Access Compliance Report

Public Rights-of-Way

(Curb Ramps)

Intersection ID: 48948	Main Street: BIRCHLEY_CR	Cross Street: DAVID_JENNINGS_AV	Location:	N
ADA ID: 1E5AB1B1C835	Ramp Type: Combination2	Initial Pass/Fail: Fail	Overall Compliance: No	Severity Score: 10

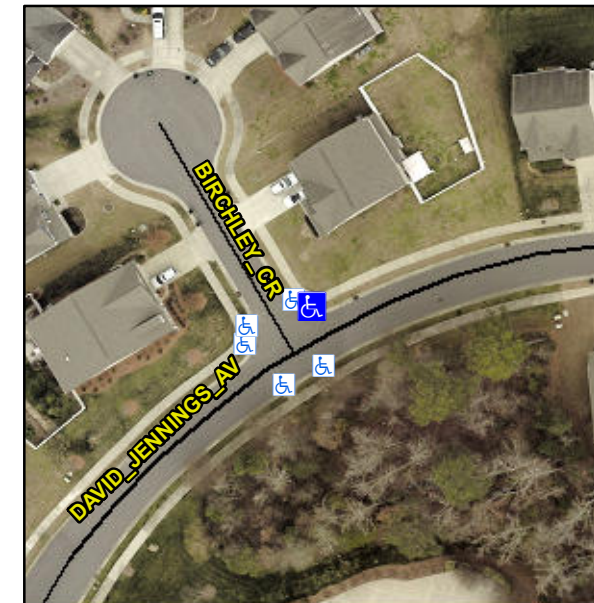
RT RP < 5%

Not Found, R304.5.1, R304.5.3

Remove & Replace Entire Ramp.
